Tesla, Inc.
Service Bulletin

Inspect and Adjust Hood Alignment

SB-25-11-003
July 16, 2025

Figure 1 – LH shown, RH similar.

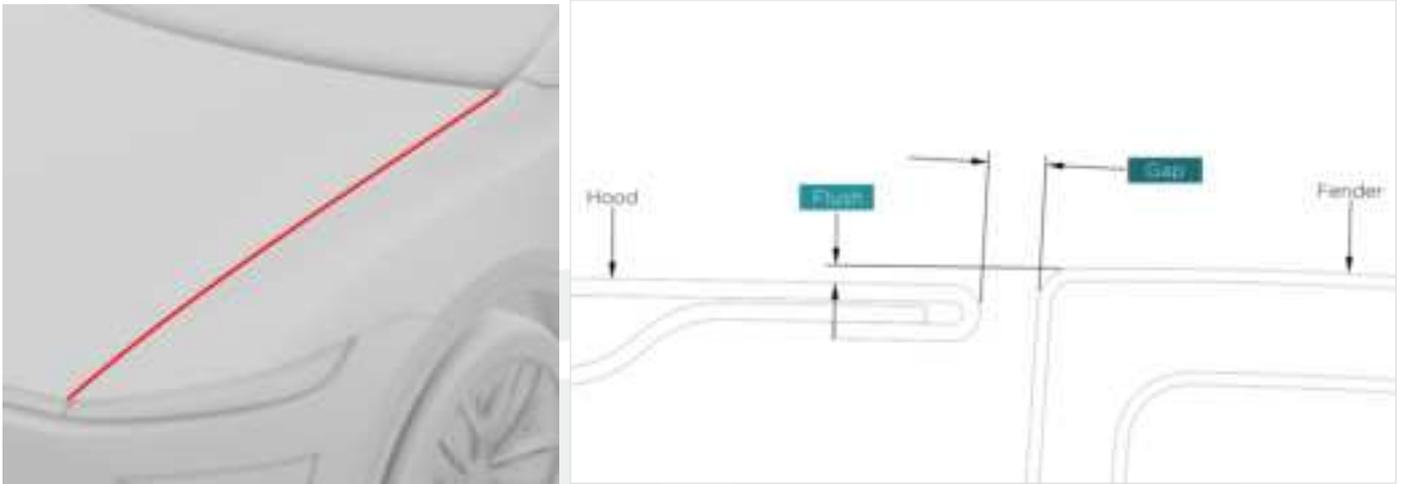
Verify that the hood opens and closes as expected, and measure the gap and flush between the hood and the fender on the LH and RH side of the vehicle (Figure 1).

Allowed gap: 1.75mm to 3.75mm. Nominal value: 2.75mm
Allowed flush: -1.90mm to -0.10mm. Nominal value: -1.00mm

- If the gap and flush are within specifications, discontinue this procedure and use correction code S012511003.
- If the gap and/or flush are not within specifications and/or the hood is not closing or opening as expected, proceed to the [Adjustment](#) section.

Figure 2 – LH shown, RH similar.

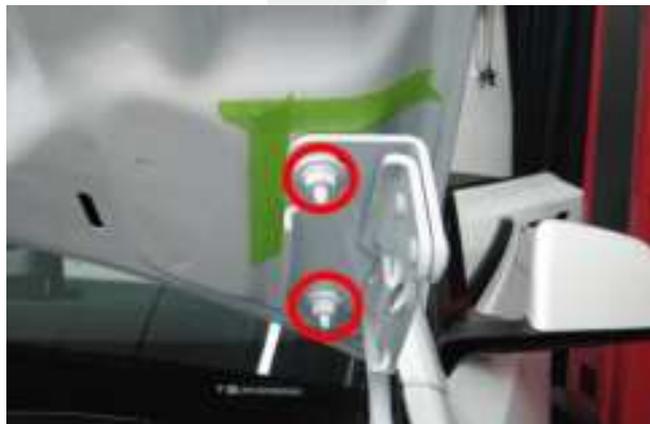
1. To ensure proper flush between the hood and the fender, as described in the [Inspection](#) section: adjust the bump stops and (if necessary) the hood latch (refer to Service Manual procedure [1133040200](#)).
2. If no gap adjustment is required, skip to step 11. If gap adjustment is required, continue this procedure.
3. Slightly loosen the nuts (x2, 13mm) that attach the hood to the LH hood hinge (Figure 2).

4. Repeat step 2 for the RH hood hinge.
5. Adjust the position of the hood to ensure proper and equal gap between the hood and the LH and RH fenders, as described in the [Inspection](#) section.
6. Hand tighten the nuts (x4, 13mm) that attach the hood to the LH and RH hood hinges.

7. Close the hood, and verify that the gap between the hood and the fenders is within specifications. Repeat steps 2 – 5 if necessary.
8. Fully torque the nuts (x4, 13mm, torque 27 Nm) that attach the hood to the LH and RH hood hinges.
9. Verify that the hood opens and closes as expected after gap adjustment. If necessary, adjust the hood latch (refer to Service Manual procedure [1133040200](#)).
10. Use IPA wipes to clean the nuts and washers (x4) that attach the hood to the LH and RH hood hinges, and then allow 1 minute to dry.
11. Apply touch up paint to the threaded studs of the hood (x4) and the nuts and washers (x4) that attach the hood to the LH and RH hood hinges.
